Access Compliance Report

Public Rights-of-Way

(Curb Ramps)

Intersection ID: 20786	Main Street: SHARON_VIEW_RD	Cross Street: SHARON_WOODS_LN	Location: SE
ADA ID: 1880ADE1A8C8	Ramp Type: PerpDiag	Initial Pass/Fail: Fail	Overall Compliance: No
Severity Score: 22.5			
Codes/Mitigation Info/Possible Solution		Field Measurements/Component Compliance

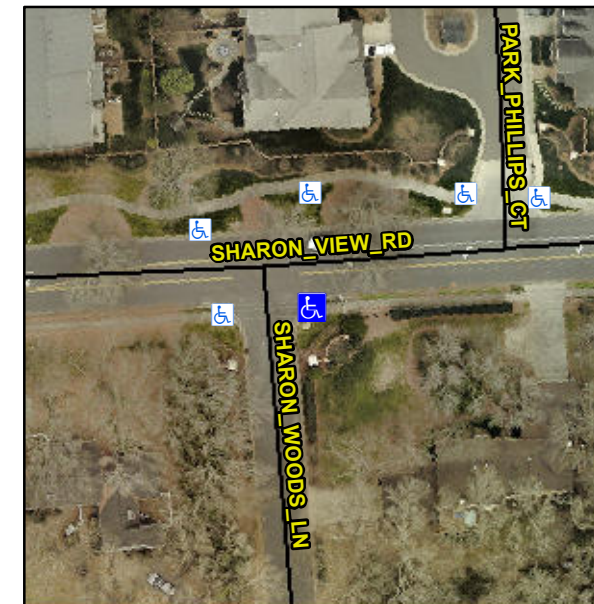
Not Found, R304.5.1, R304.2.2, R304.5.3

Compliance	Description	Data	Compliance	Description	Data
N/A	Ramp Length (in)	48.0	No	Ramp Slope (%)	10.4
No	Ramp Width (in)	44.0	No	Ramp XSlope (%)	2.1
N/A	Flare Type LT	N/A	N/A	Flare Type RT	N/A
N/A	Flare Slope LT (%)	N/A	N/A	Flare Slope RT (%)	N/A
N/A	Flare Traversable LT?	N/A	N/A	Flare Traversable RT?	N/A
N/A	Landing Length (in)	N/A	N/A	DWS Provided?	N/A
N/A	Landing Width (in)	N/A	N/A	DWS Contrast?	N/A
N/A	Landing Slope (%)	N/A	N/A	DWS Length (in)	N/A
N/A	Landing X Slope (%)	N/A	N/A	DWS Full Width?	N/A
N/A	Landing Curb? (Y/N)	N/A	N/A	DWS Offset (in)	N/A
N/A	Shared Landing?	N/A			
N/A	Gutter Ponding?	N/A	N/A	Gutter Slope (%)	N/A
N/A	Gutter Lip Ht (in)	N/A	N/A	Gutter X Slope (%)	N/A
N/A	Painted X Walk1?	No	N/A	Painted X Walk2?	No
	X Walk 1 Direction	To NE		X Walk 2 Direction	To NW
N/A	X Walk 1 Width (in)	N/A	N/A	X Walk 2 Width (in)	N/A
	X Walk 1 Slope (%)	9.3		X Walk 2 Slope (%)	3.3
	X Walk 1 X Slope (%)	3.6		X Walk 2 X Slope (%)	8.2

Remove & Replace Curb Ramp With Two New Directional Ramps or Equivalent.
